Meeting Agenda Historical Preservation Board

Monday, December 19, 2016

- a. [HPB Resolution 02-2016](#) Resolution to approve a COA for new development at 2679 West Main Street

CASE # COA16-0003

SITE PLAN

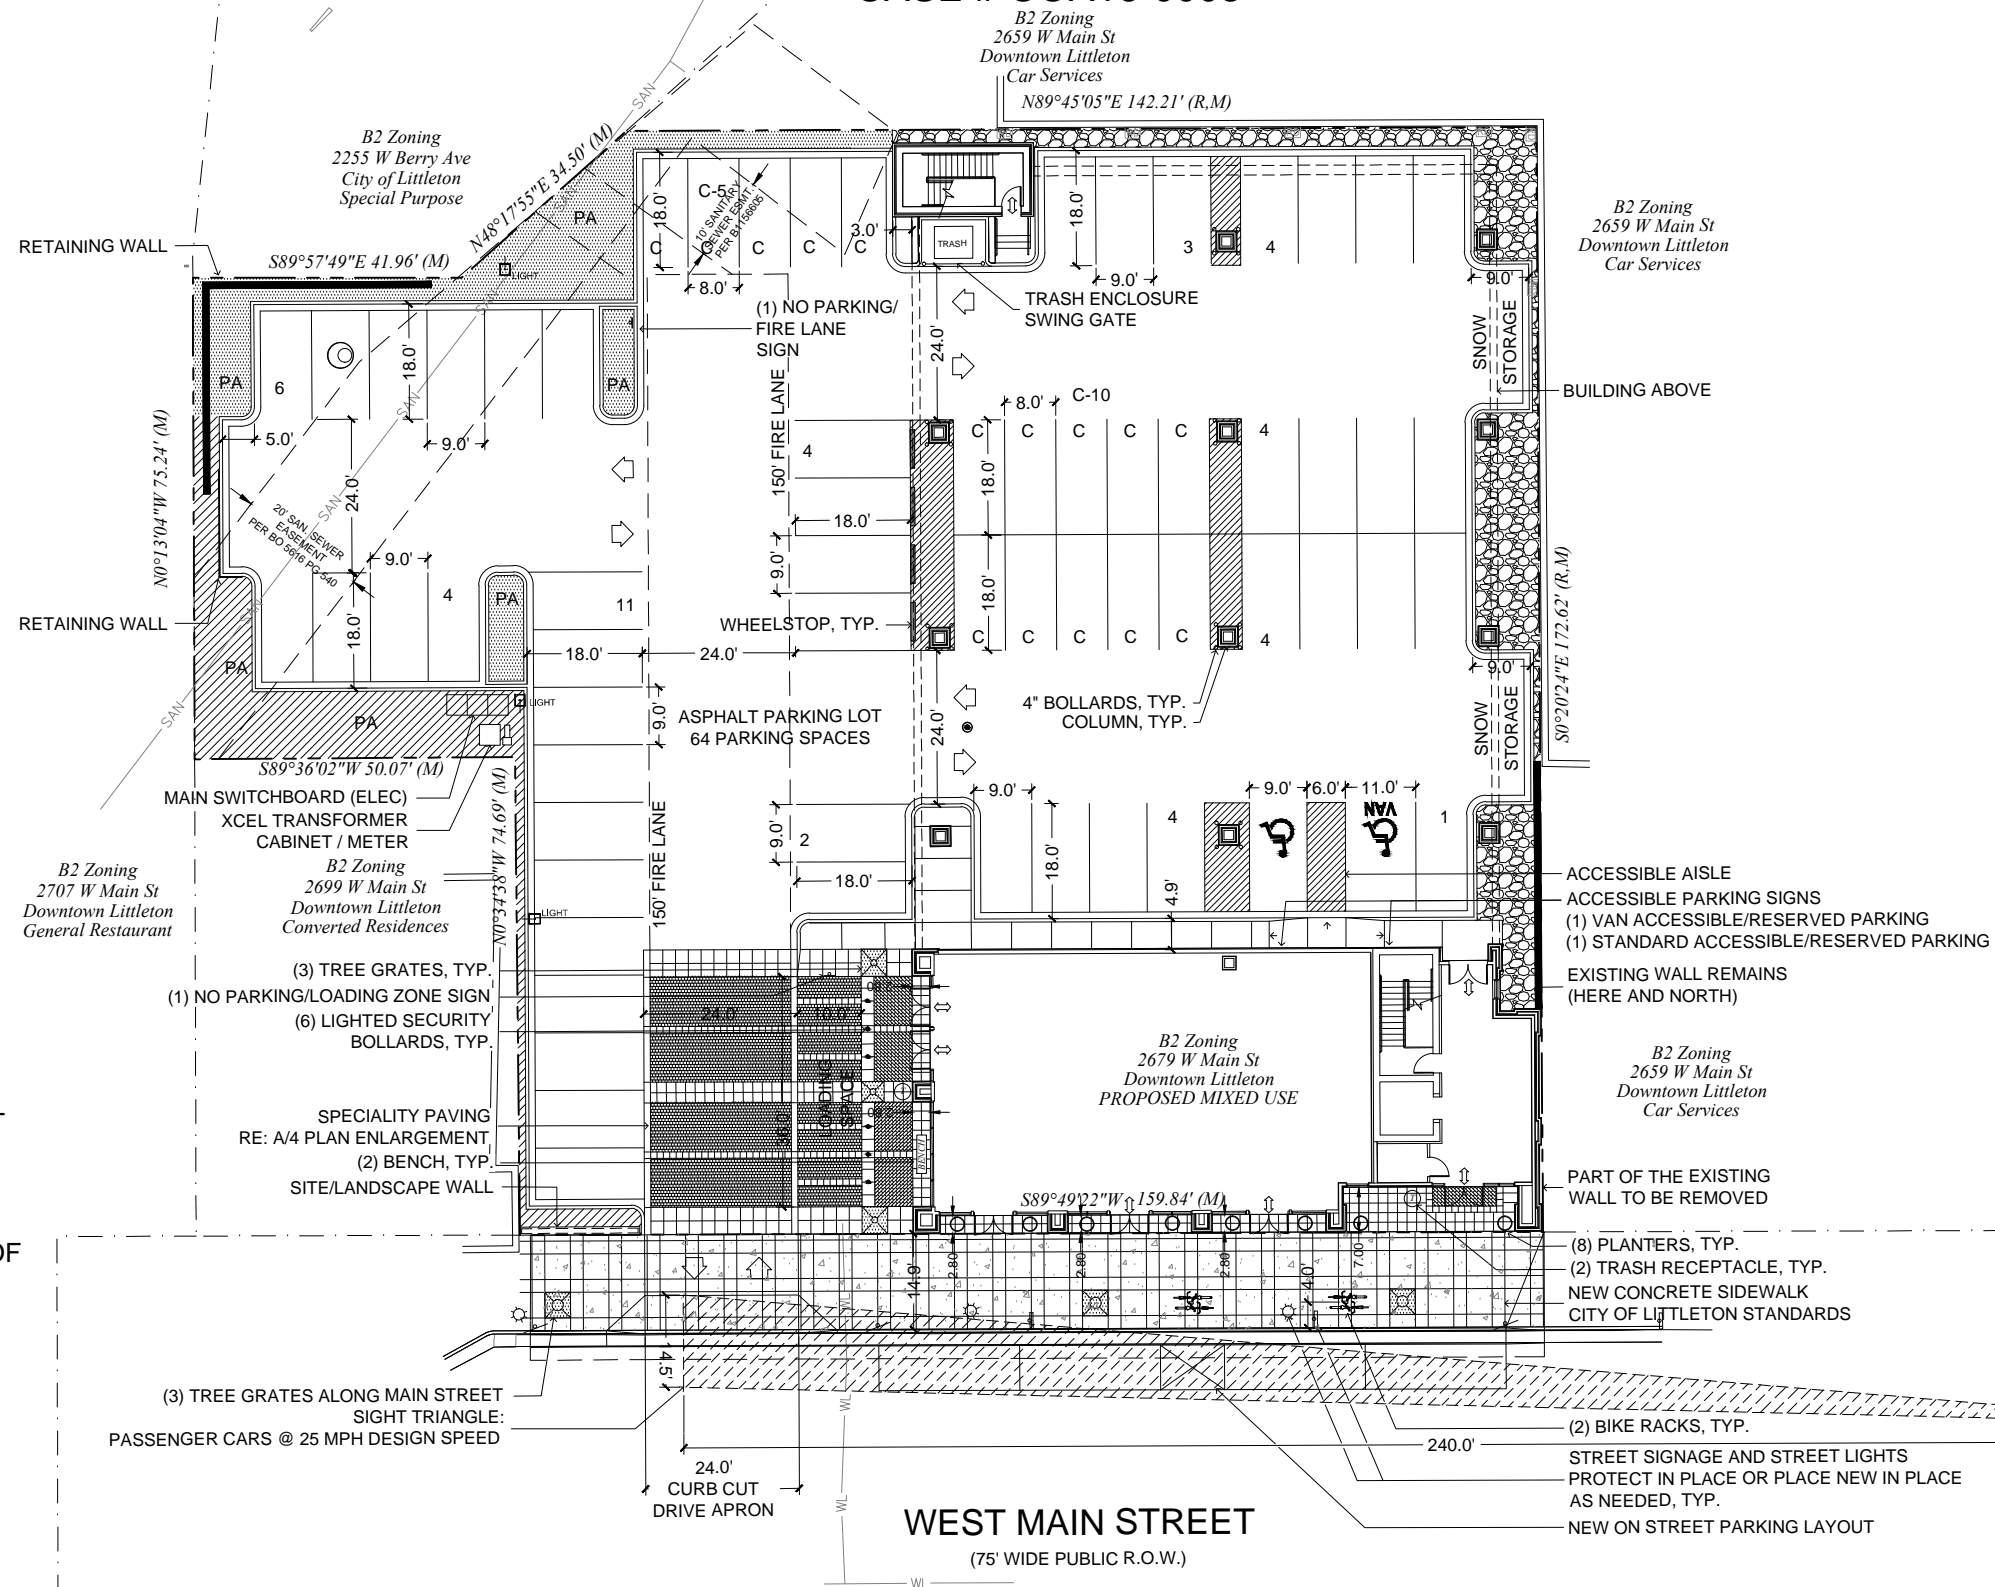
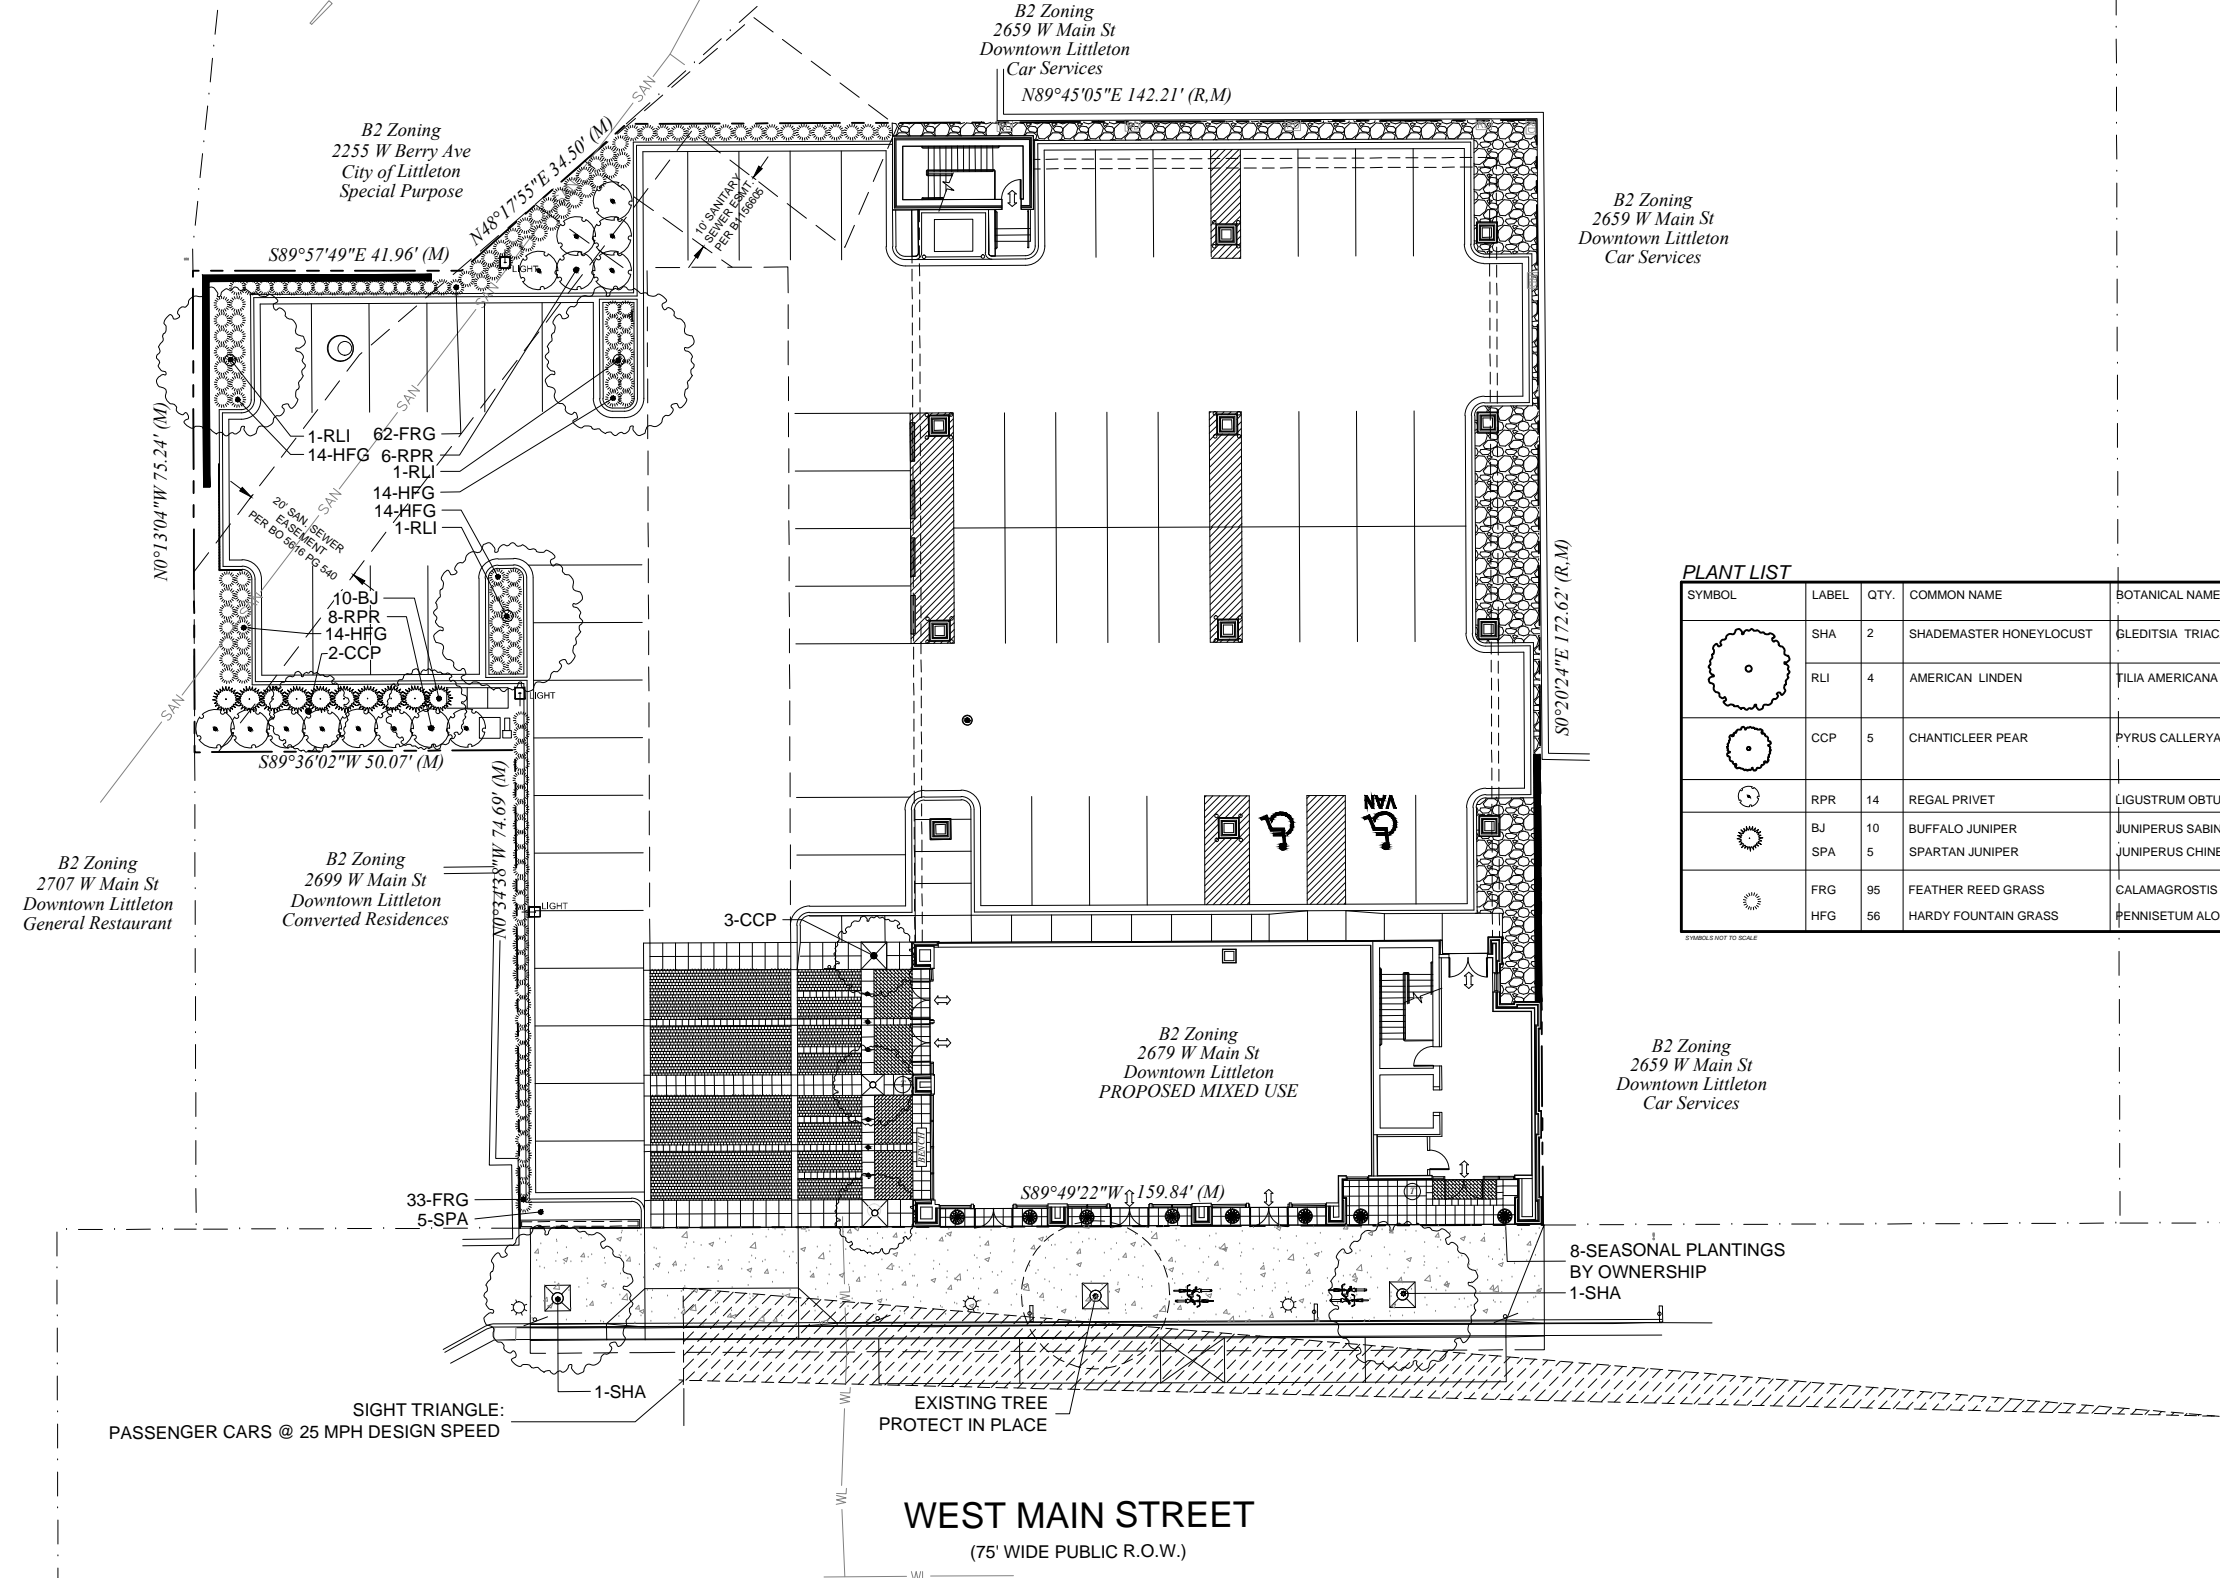
Although the proposed project has a two-way driveway that crosses the sidewalk on the north side of Main Street and has a curb cut associated with that driveway, the driveway and curb cut are necessities because the site is not serviced by an alley. The proposed project limits driveways and curb cuts to one and the applicant has worked with the Public Works Department to meet city engineering standards and to provide the width of driveway and curb cut that balances the needs and safety of vehicular and pedestrian traffic.

The proposed site layout does not meet Standard 5.2.3.s1 in that there is a vehicular access from Main Street and an onsite parking lot located at the side and rear of the property. However, section 8.15 of the Design Standards and Guidelines allows for deviations from design standards when unique site factors exist and when an alternative can achieve the stated intent. The site is unique in that it has no opportunity to take access from side streets, forcing parking lot access to be directly from Main Street. In response to the limitations of the site, the applicant has provided a site wall that screens the parking from Main Street using material from the building creating the continuity desired in the standard.

NOTE:
THE DRIVEWAY
LOCATED ACROSS
THE MAIN STREET
SIDEWALK SHALL
MAINTAIN ATLEAST
A SIX FEET WIDE
PORTION OF THE
SIDEWALK AT A
MAXIMUM SLOPE OF
3 PERCENT.

SIGNAGE ENLARGEMENT (1/4" = 1'-0")

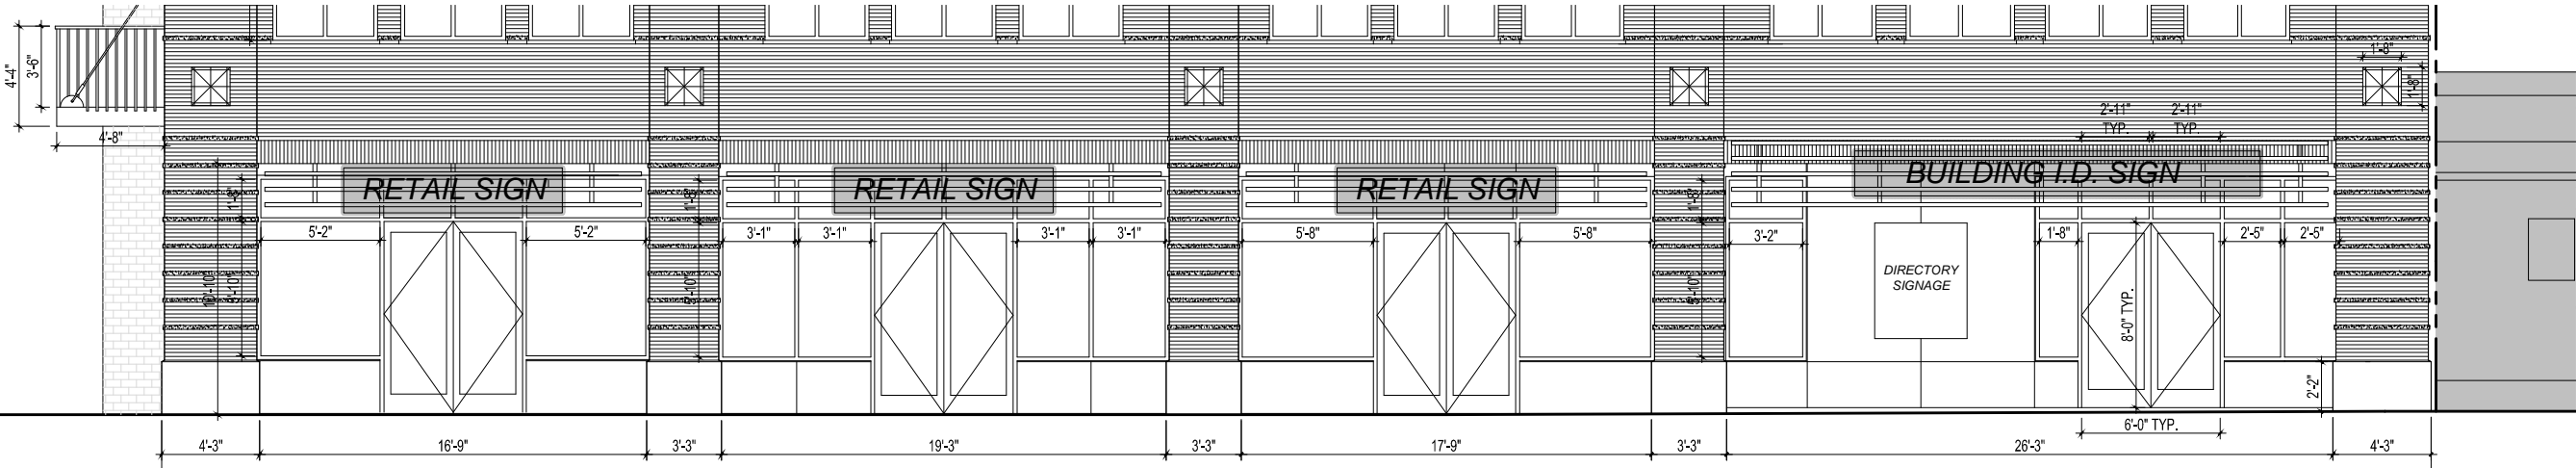
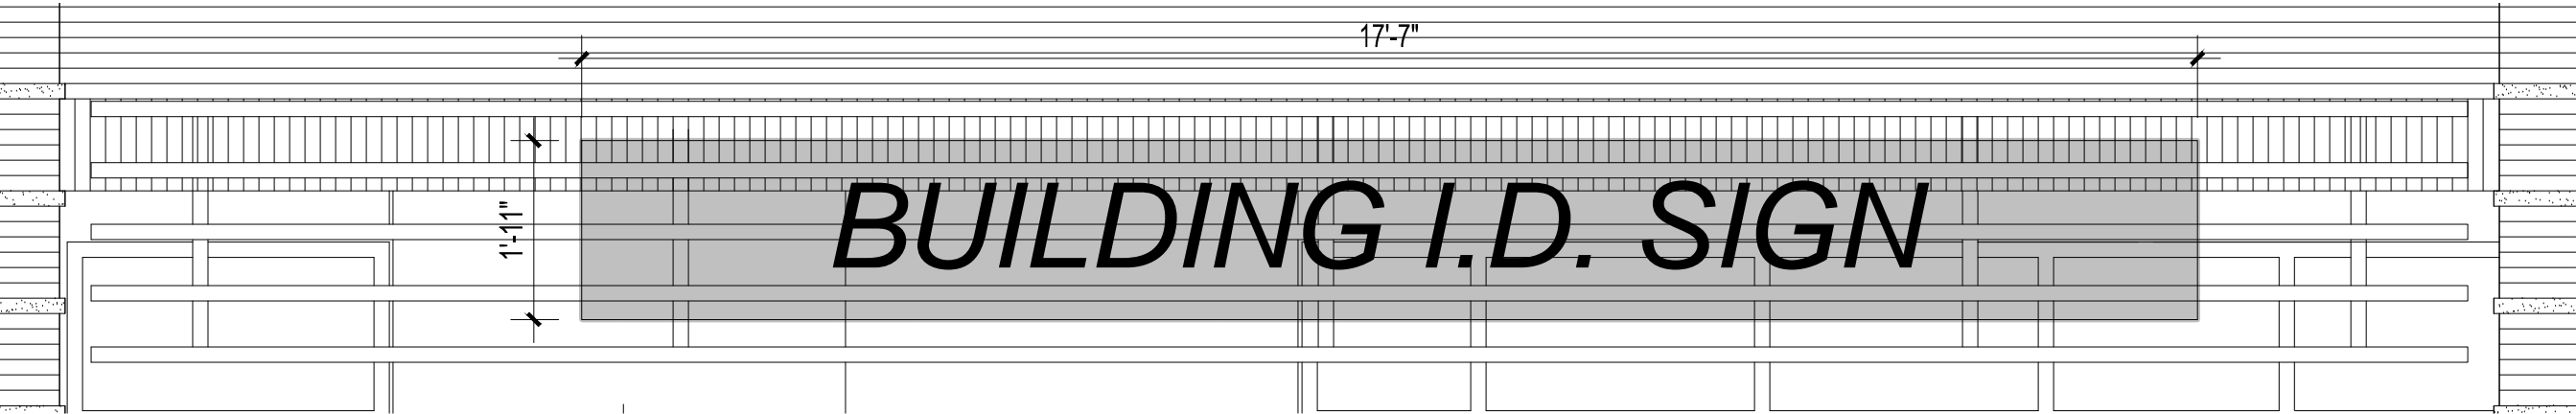
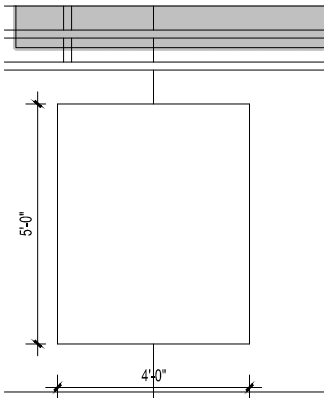
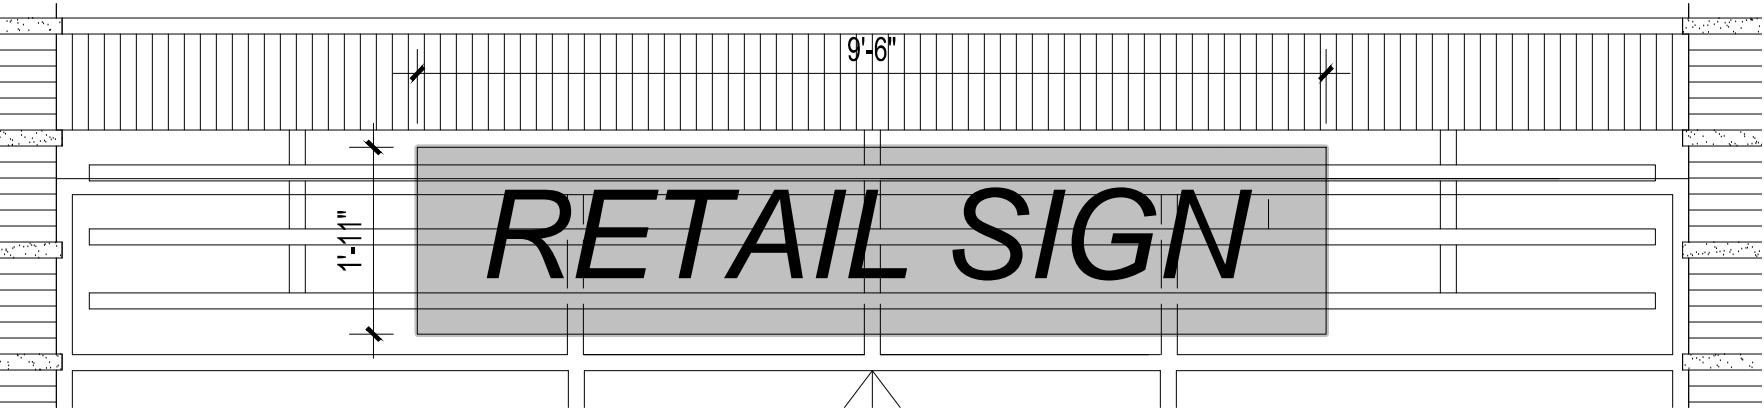
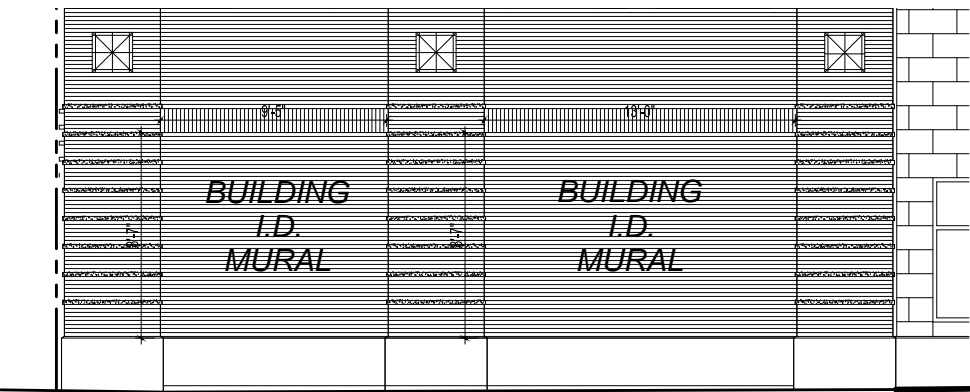
The drawings show the general locations, sizes, heights, and probable design and illumination of all sign types used on the building. As noted on the drawings, a separate staff level COA must be sought for specific signs and will be reviewed for compliance with the sign code and applicable design standards.

As noted on the drawings, a separate staff level COA must be sought for specific signs. While the drawings show the general location and size of signs, the sign COA will review the detailed design, size, and lighting of individual signs for conformance with the sign code and the above applicable design standards.

The drawings are not showing any projecting signs. As noted on the drawings, a separate staff level COA must be sought for specific signs. While the drawings show the general location and size of signs, the sign COA will review the detailed design, size, and lighting of individual signs and will be reviewed for compliance with the sign code and applicable design standards.

NOTE:
A SEPARATE STAFF-LEVEL COA MUST BE SOUGHT FOR SPECIFIC SIGNS
